WATERVIEW EAST PRELIMINARY PLAN

LOCATED IN A PORTION OF SECTION 9, T15S, R65W OF THE 6TH P.M.,
EL PASO COUNTY, STATE OF COLORADO

Computer File Information	
Creation Date: 2-27-17	Initials: CMD
Last Modification Date: 4-3-17	Initials: BG
Full Path & Drawing File Name: V:\1817\active\181710214\CAD\Plansheets Title Sheet	
Acad Ver. 2014	Scale: see plan Units: Feet

WATERVIEW EAST PRELIMINARY PLAN		Project No./Code
		181710214
Designer: CMD/BG	Structure Numbers	Sheet Number 5 of 9
Detailer: PF/BG		
Sheet Subset:

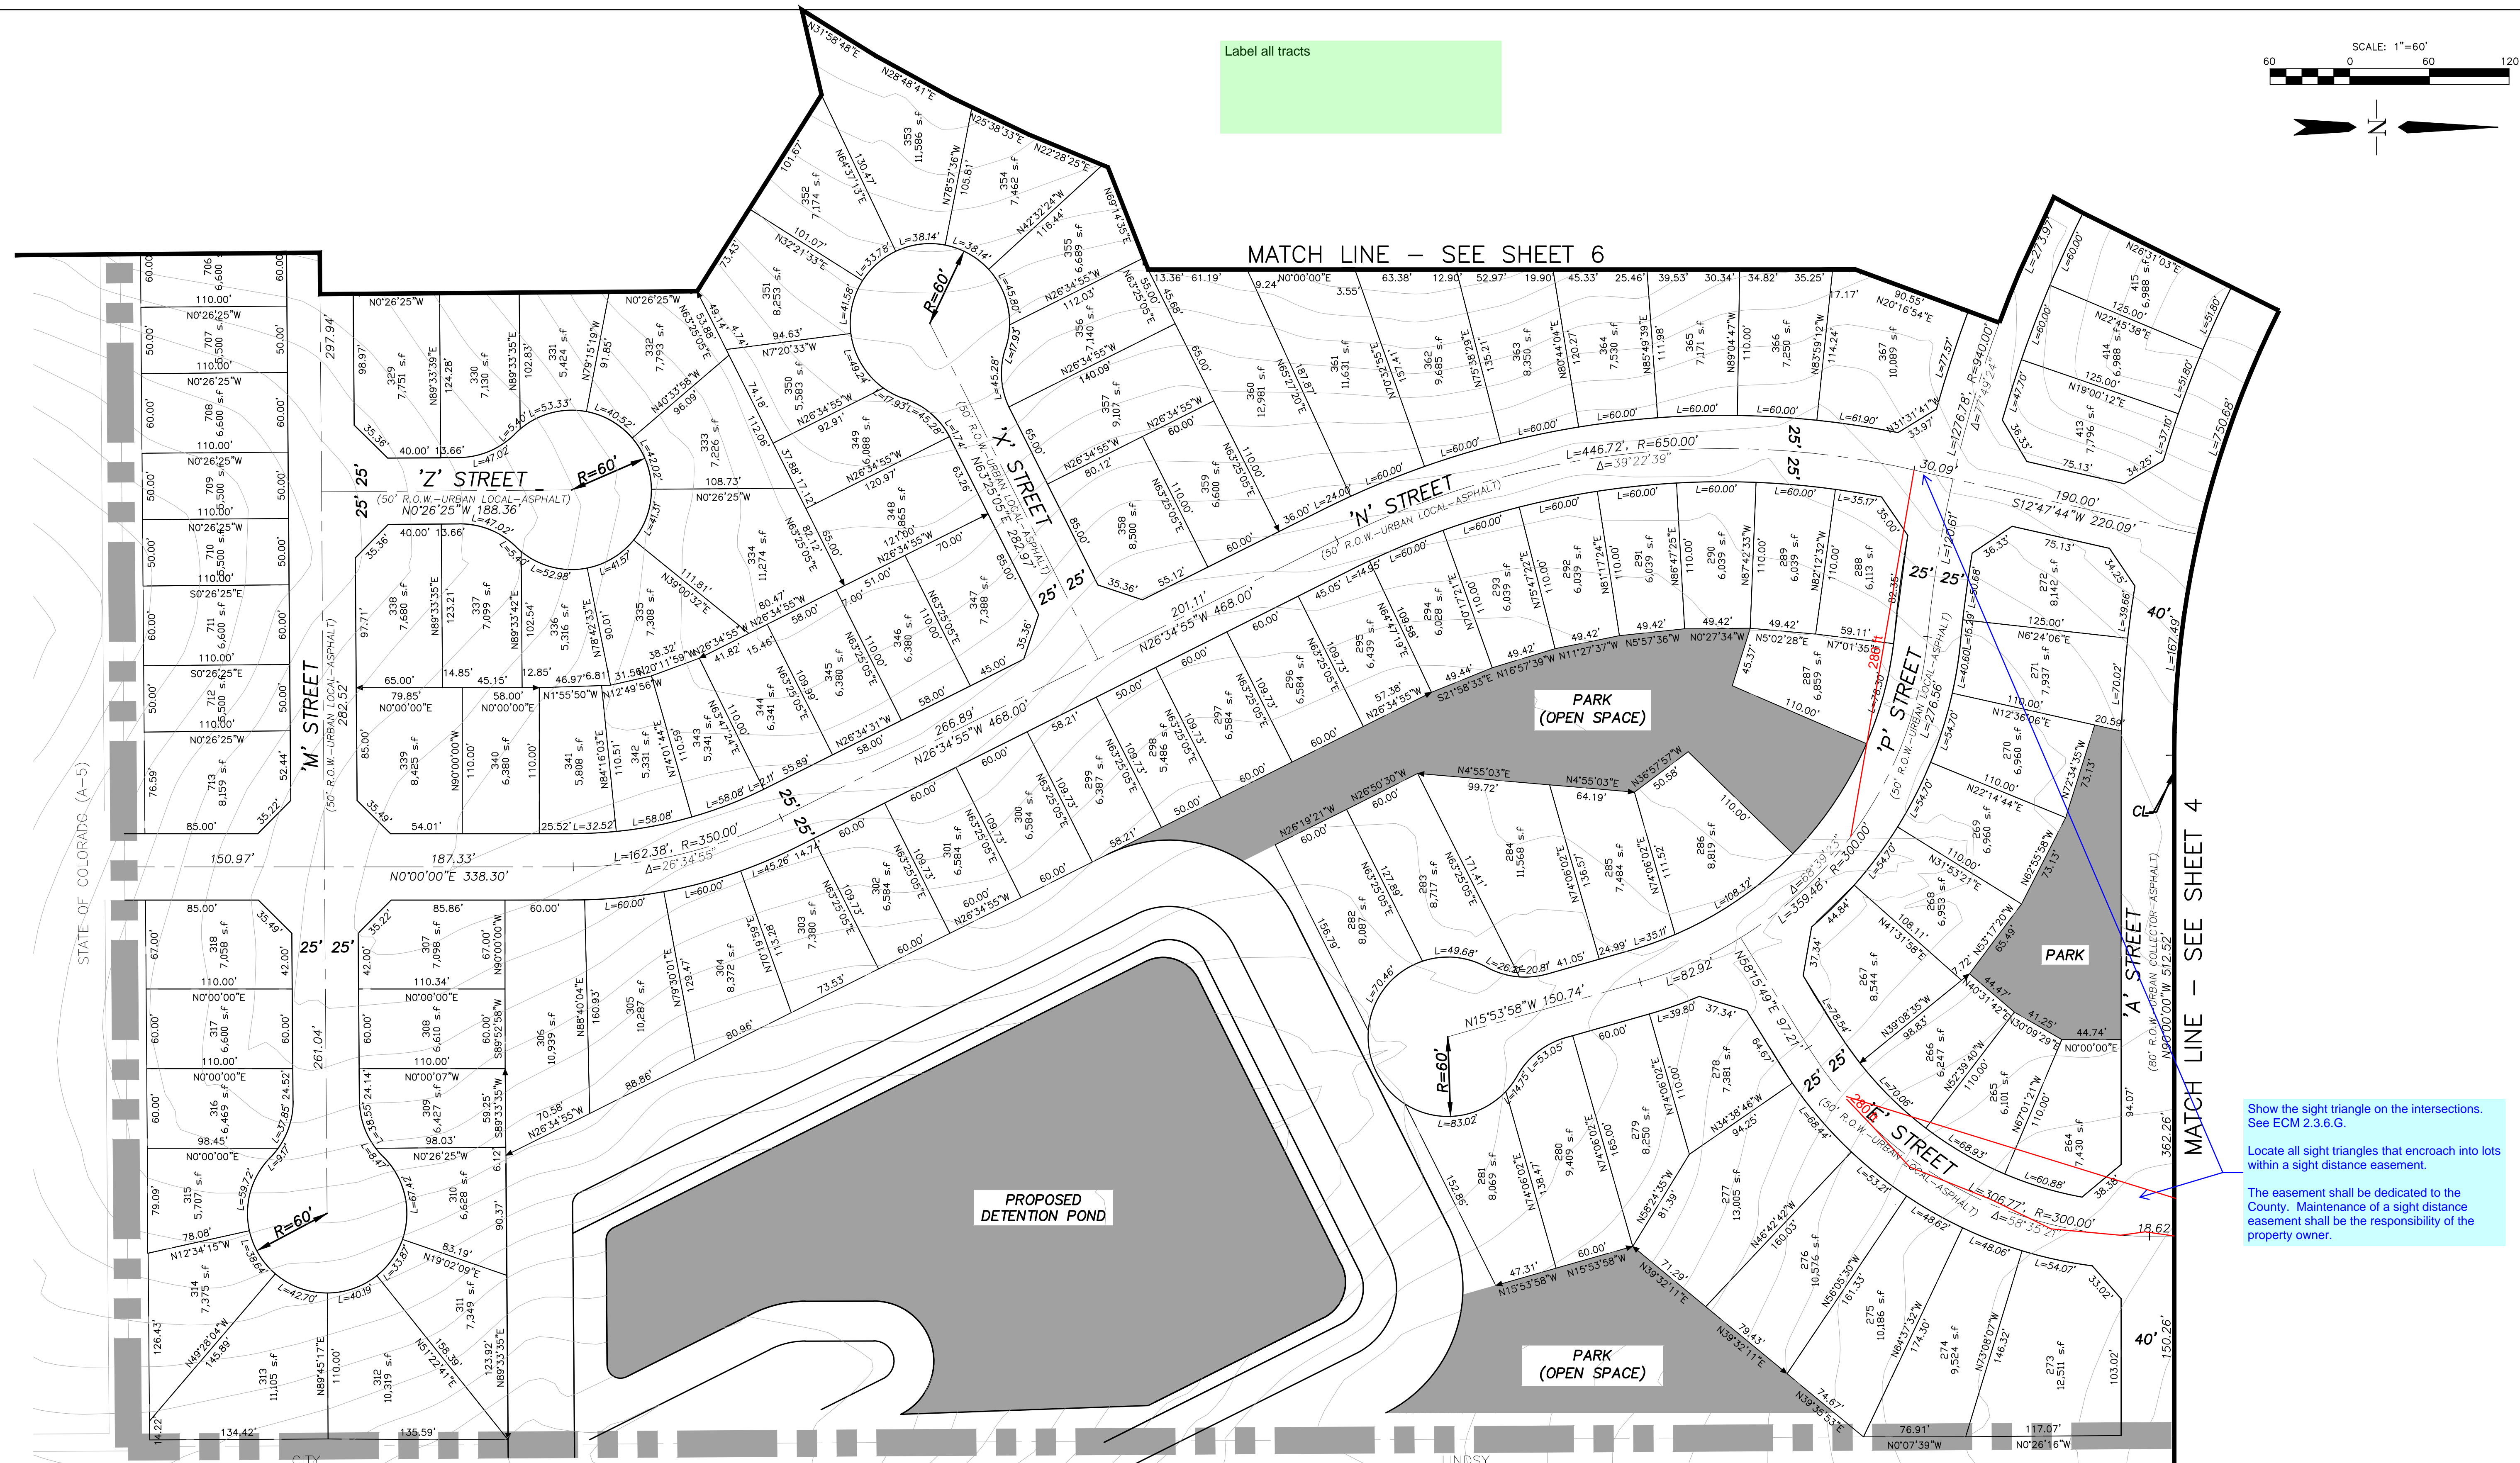
Label all tracts

Show the sight triangle on the intersections. See ECM 2.3.6.G.
Locate all sight triangles that encroach into lots within a sight distance easement.
The easement shall be dedicated to the County. Maintenance of a sight distance easement shall be the responsibility of the property owner.

Project No./Code	181710214
Sheet Number	6 of 9

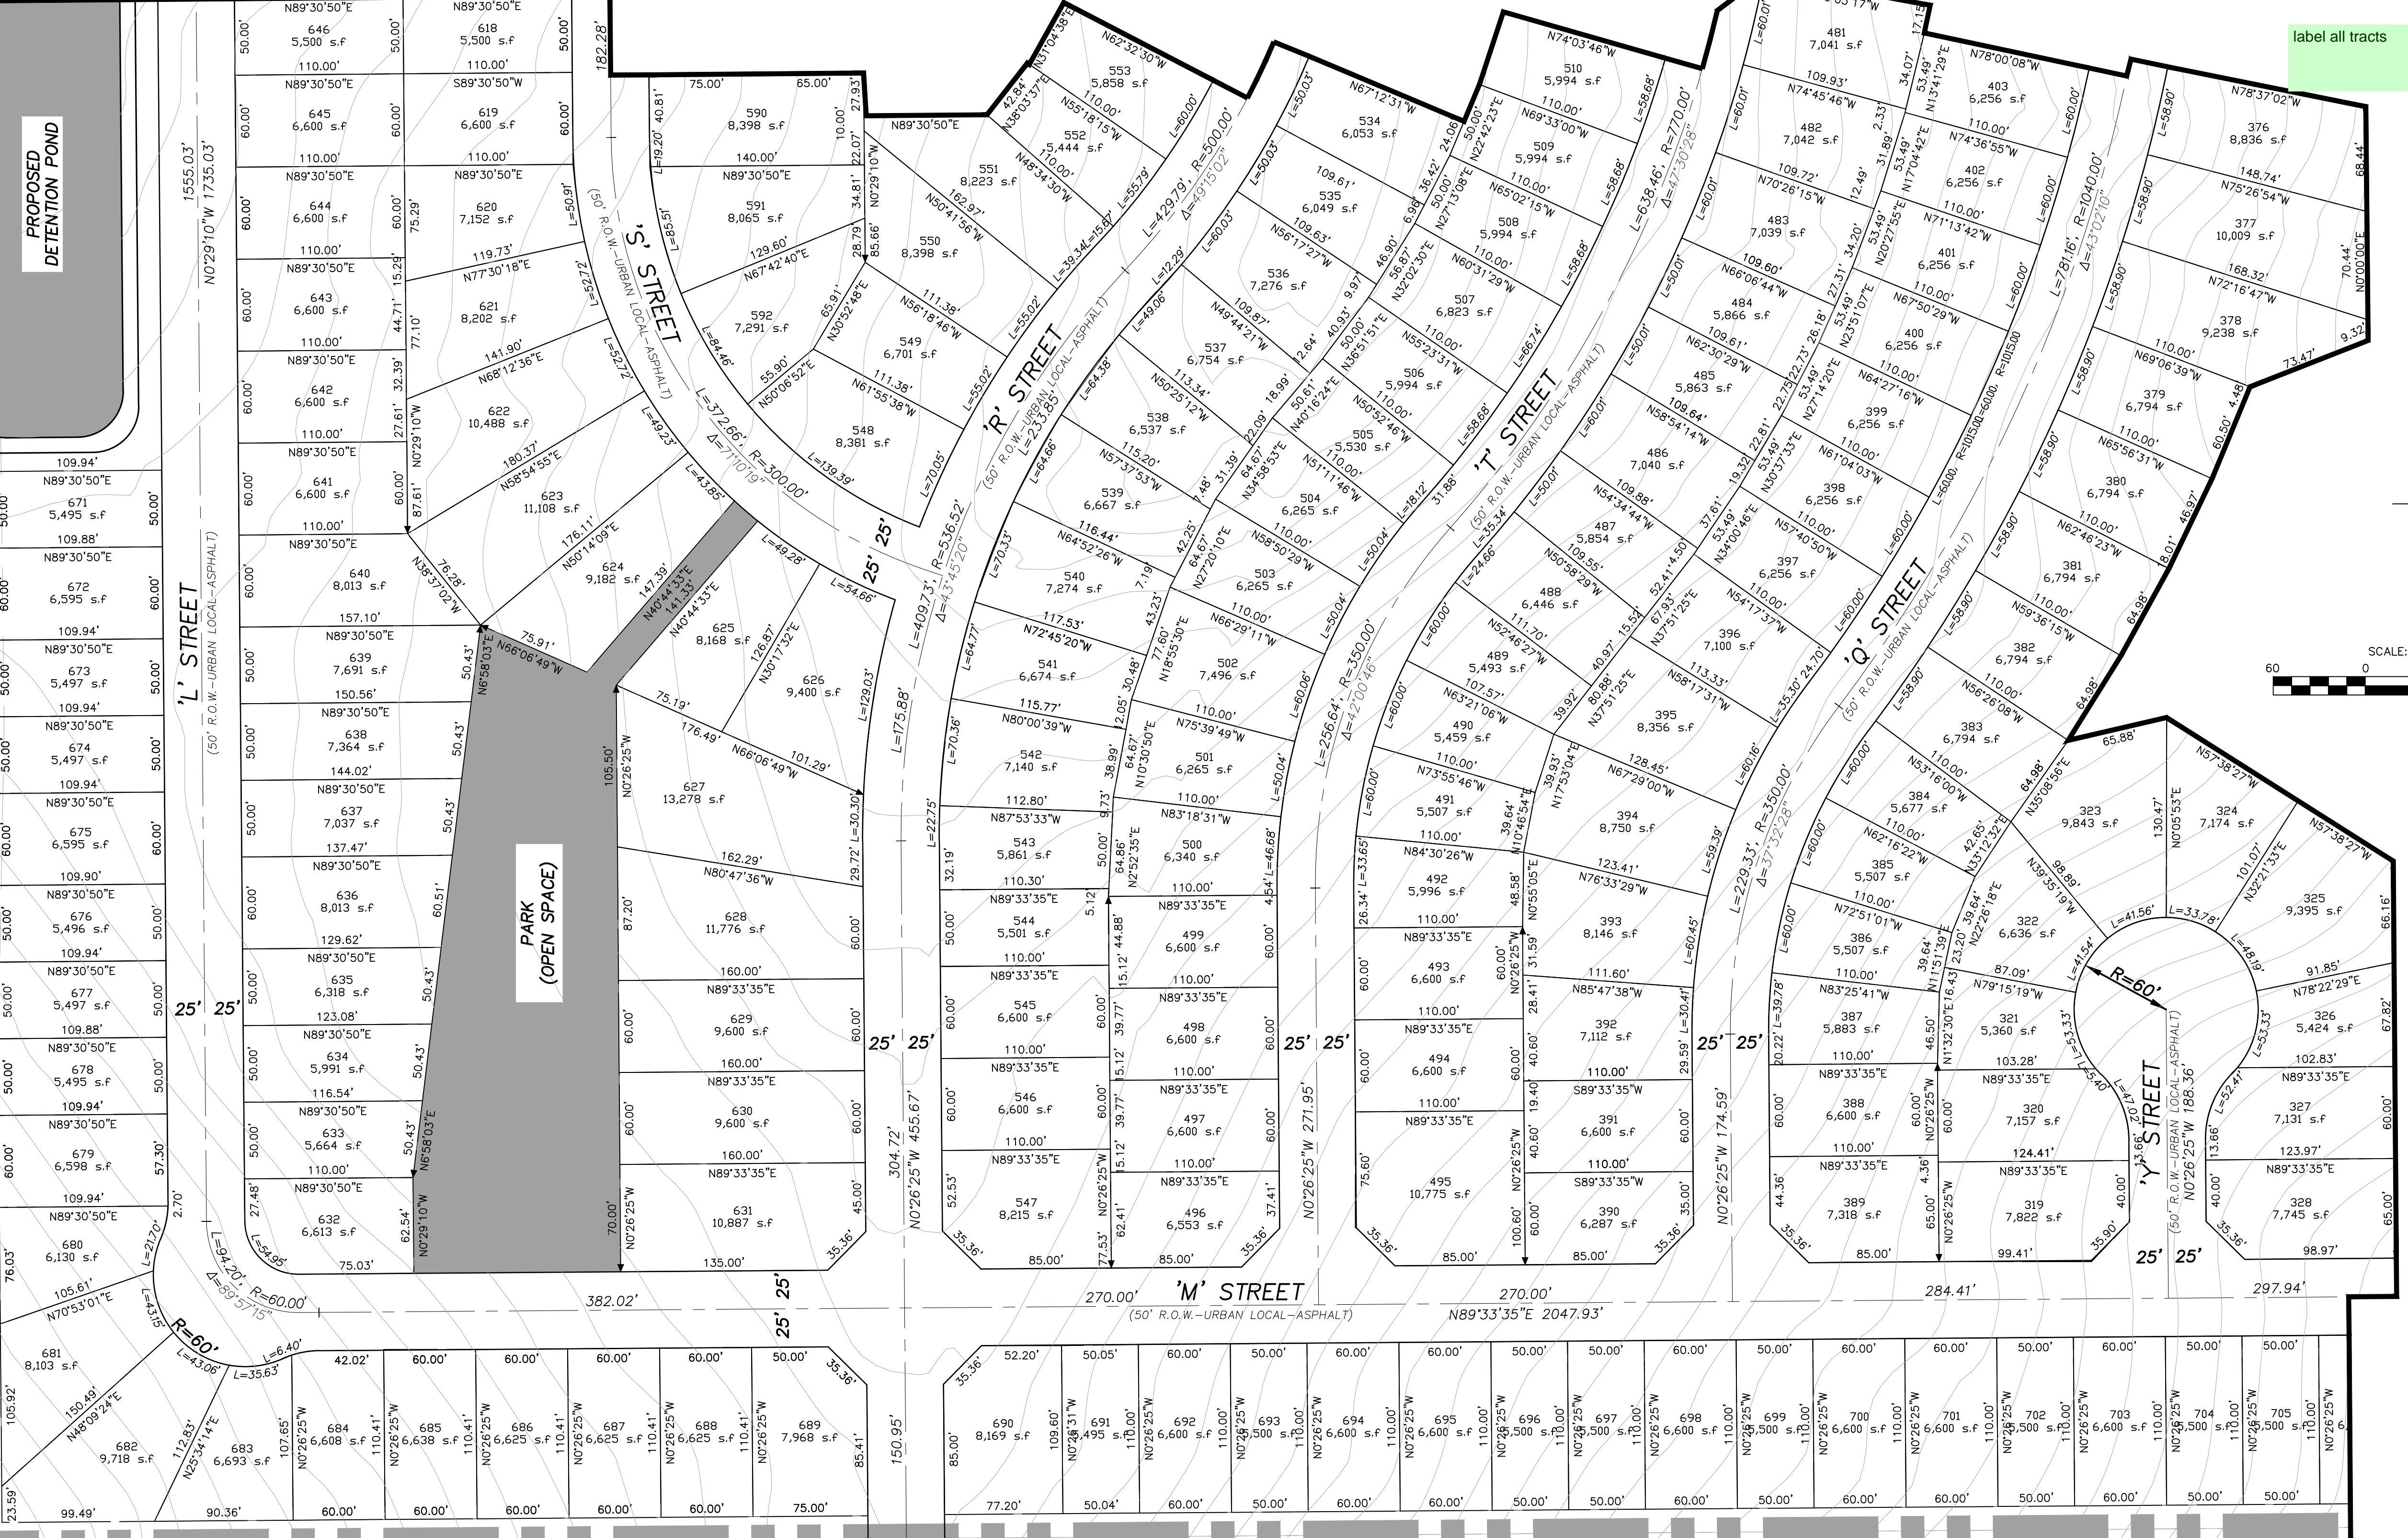
label all tracts

Project No./Code 181710214
Sheet Number 8 of 9

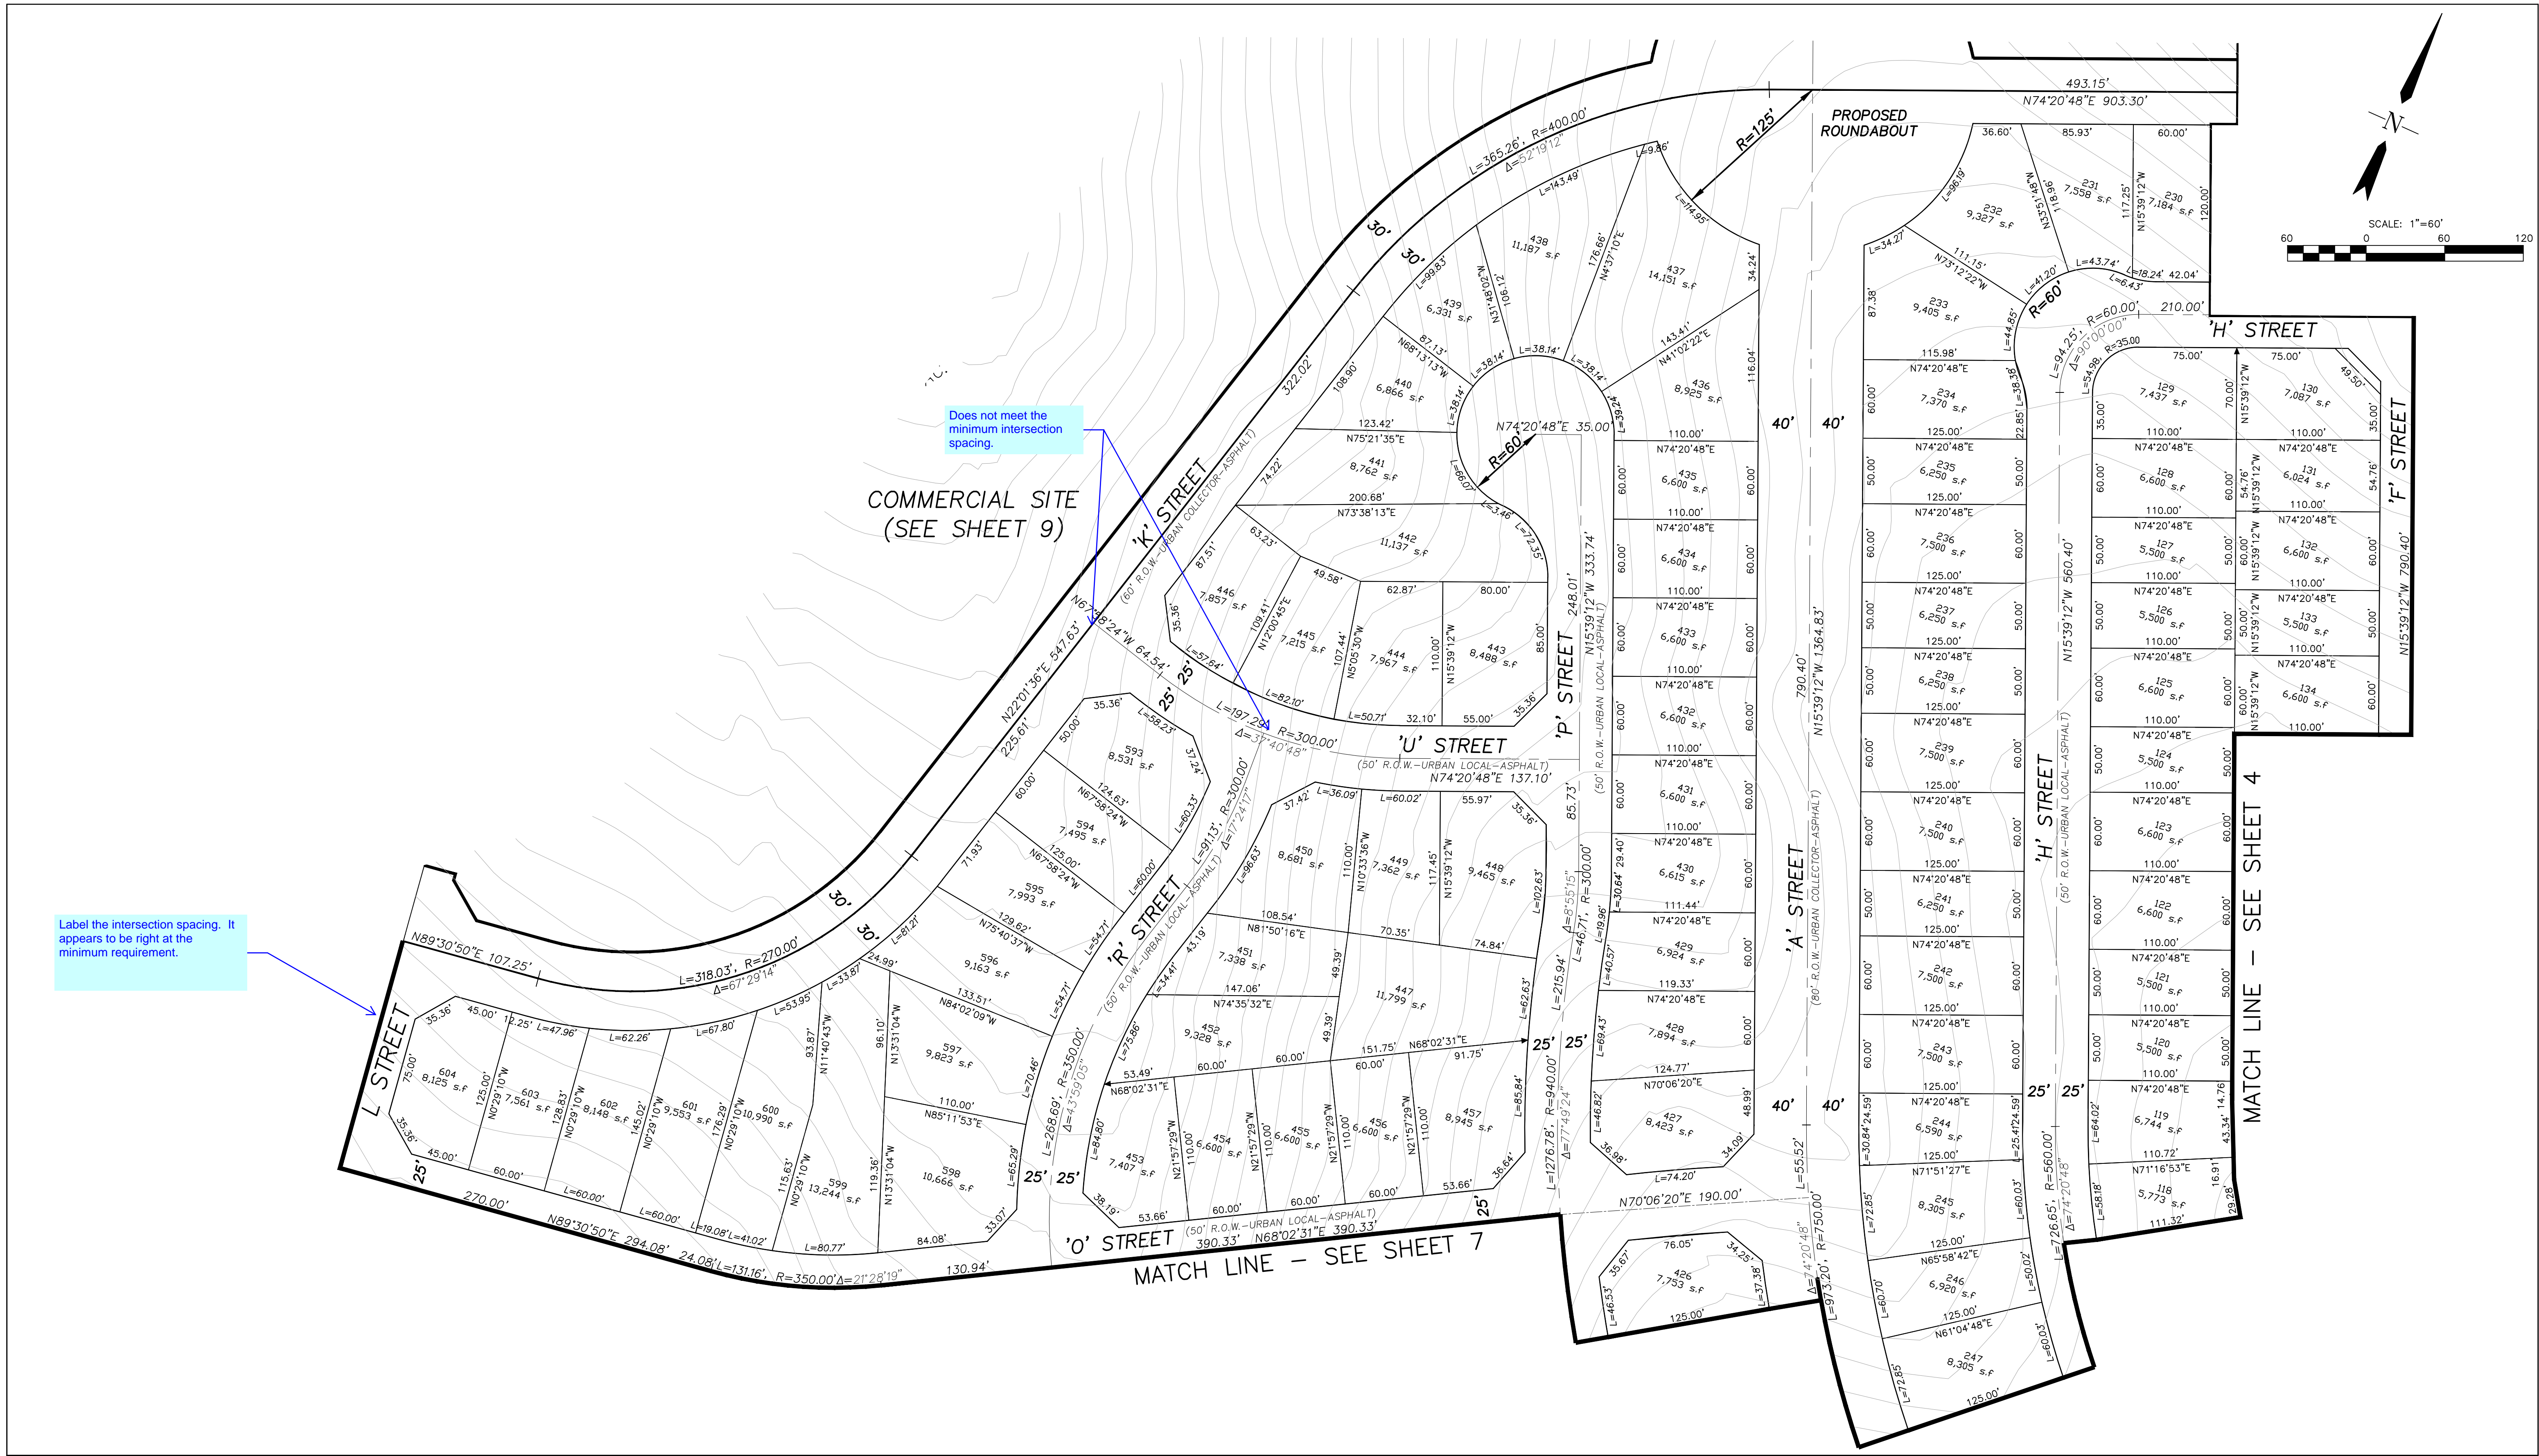
Does not meet the minimum intersection spacing.

Label the intersection spacing. It appears to be right at the minimum requirement.
